MONTHLY PROGRESS REPORT

# KENDALL COUNTY

NEW OFFICE BUILDING

Section 5: Architectural & Engineering Field Reports

Gaps at Door 1B

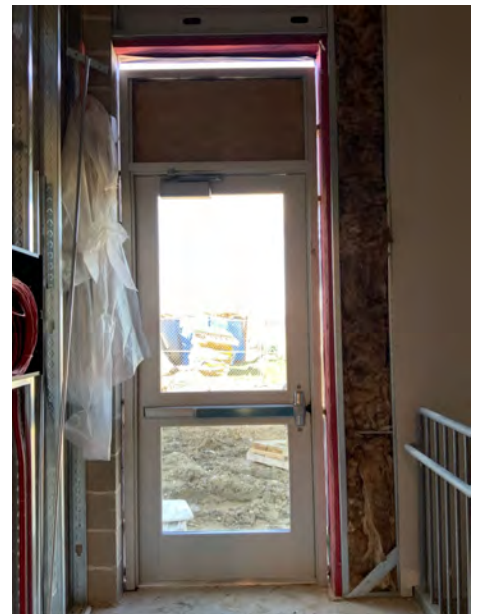
1. Aluminum fascia trim at interior corner of entrance is bent and needs to be repaired or replaced.
2. At door frame 1B there is an approximate 1" gap on jamb sides and approximate 3" gap at head. Will this gap at the head affect the masonry, lintel or flashing detail? Can framing adjustments accommodate?  
In Staging/ Work Area 106, the steel frame at the knee wall partition type D is lower than top of wall, replace as required to meet deflection requirements noted on A2.2.
3. In Stair 1A, grind rough edges where CMU was patched for a clean and smooth surface.
4. Fire alarm systems are required to meet ADA compliance, adjust FACP height in Stair 1A so that any operable components are no higher than 4'-0" AFF.

Fire Rated Shaft Wall Type F

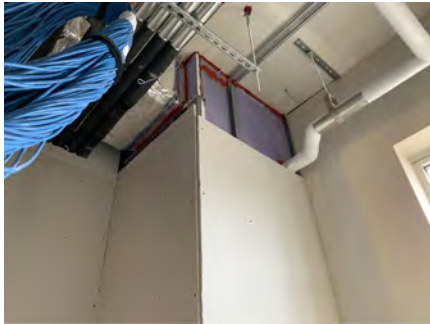
1. CCA to verify if the receiver piece in detail 8/A4.2 is required per on site discussion with CM.
2. Verify the exterior gyp. board will align with the top of cast stone and brick veneer per details on A6.4.
3. On south exterior, there is a portion of the cast stone with cut mortar joints, verify if this will be infilled with mortar to match adjacent.
4. In Janitor 109, the self leveling compound has been applied to the entire floor, verify if scheduled sealed concrete finish can be applied to the compound.
5. Verify the fire rated shaft wall partition type F is constructed to meet UL assembly U415 per A2.2.

Decorative Trim Mock-up

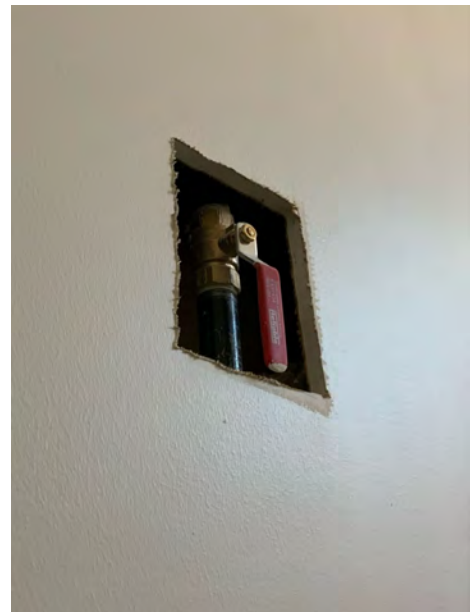
1. In Stair 0A, the sprinkler line valve extends past the gypsum finish, confirm if this will conflict with access panel installation. Can this valve be adjusted?
2. In the barrel vault, decorative wood trim mock-up was reviewed in field. No exception is taken to trim mock-up, confirm interior corner cuts are precise and finished to prevent separation.
3. For Door 100A and 100B, provide protection at base of door and around handle to prevent potential damage, for the duration of construction.
4. In Work Room 119, there is minor de-lamination at the top of the cabinet in south west corner. Repair.
5. At Southeast corner, soffit cut around light fixture is larger than fixture. Replace soffit piece.

Reception Counter in Clerk

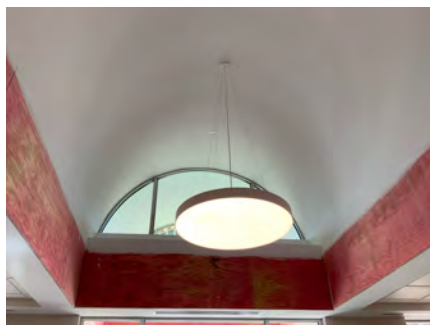
1. In Stair 0A, verify door clearance of 18" from interior side of jamb to face of return rail is maintained.
2. In Staging/ Work Area 106, verify counter depth is 2'-6" per detail 7/A8.8.
3. At Clerk, Recorder and Voter reception areas, verify all internal electrical runs are coordinated.
4. At Northwest corner, verify water is not accumulating due to incoming water line.
5. At North and South sides of entry, verify soffit vent is installed per detail 4/A6.4.
6. A cast stone jamb is damaged on North and some areas on West are chipped, verify repair.
7. Architect to verify locations of cameras with security contractor.
